DEVELOPMENT REVIEW BOARD REPORT

Hazel & Azure - Camelback 37-DR-2021#2	Request for approval of hardscape and landscape plans for the canal bank improvements associated with the Hazel & Azure mixed-use development (37-DR-2021).
---	---

37-DR-2021#2

STAFF EXHIBIT:REQUIRED CANAL BANK IMPROVEMENTS, PER ORD. NO. 3909. 1 of 2

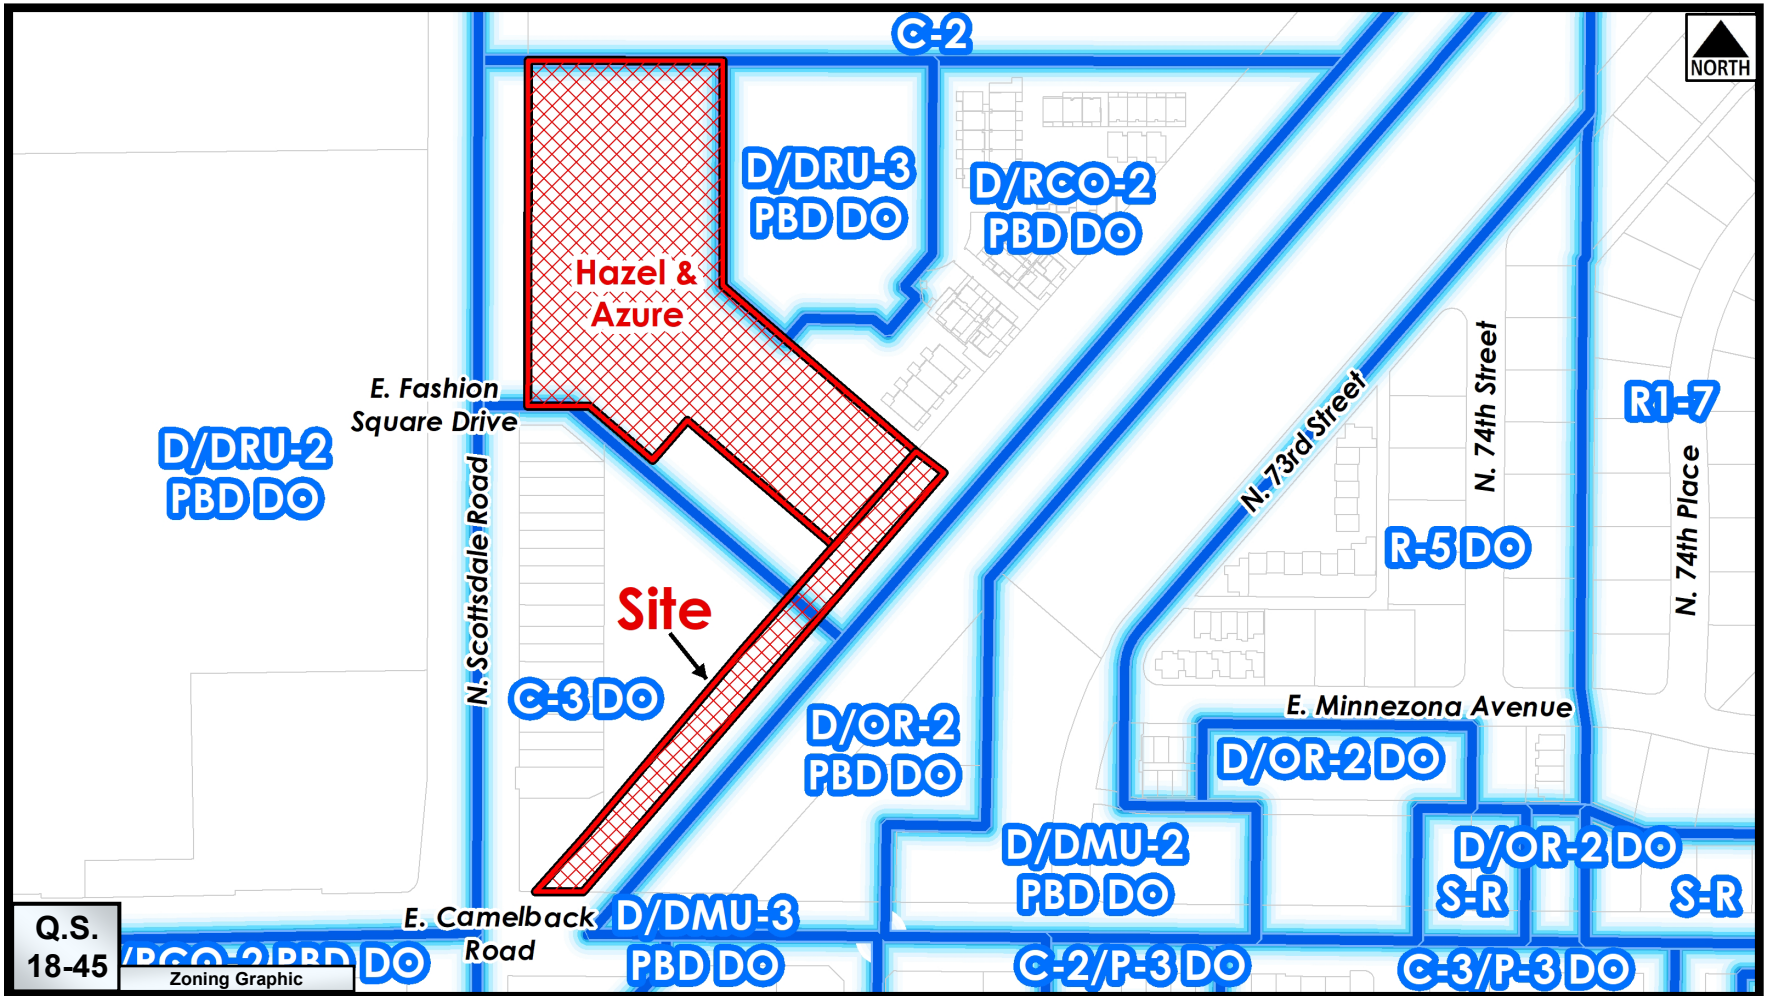
As discussed, Hazel and Azures current canal bank proposal is unacceptable as it does not meet their stipulation from 2007 (see attached). Please note that the approved plan already considered the box culvert inlet condition and proposed a short retaining wall along the outside edge of the canal ROW. Even if FCD does not allow a small retaining wall in their ROW, there's plenty of room to widen the top of bank and simply slope the outer edge to catch grade, as depicted on the image below. Another option is to raise the box culvert inlet. Have either of these options been explored? I understand that they may have run into resistance from SRP/FCD but defaulting to leaving this segment narrow in lieu of exploring all options is not right or in the best interest of the City, the community &/or the surrounding properties. Nobody bothered to reach out to us. As discussed, it is critical to provide the full width improvements, not only from an esthetic value at this key location, but also to create enough space for the eventual bridge to land that will be extended across the canal from our proposed Edition hotel to the east.

In summary, there are solutions that do not appear to have been considered. I suggest a stipulation that requires them to either comply with the full-width requirements, or suggest you continue the case to allow time for proper coordination between vested parties. Unfortunately, the first we heard of their intent to do something other than what was approved, is from your email of yesterday.
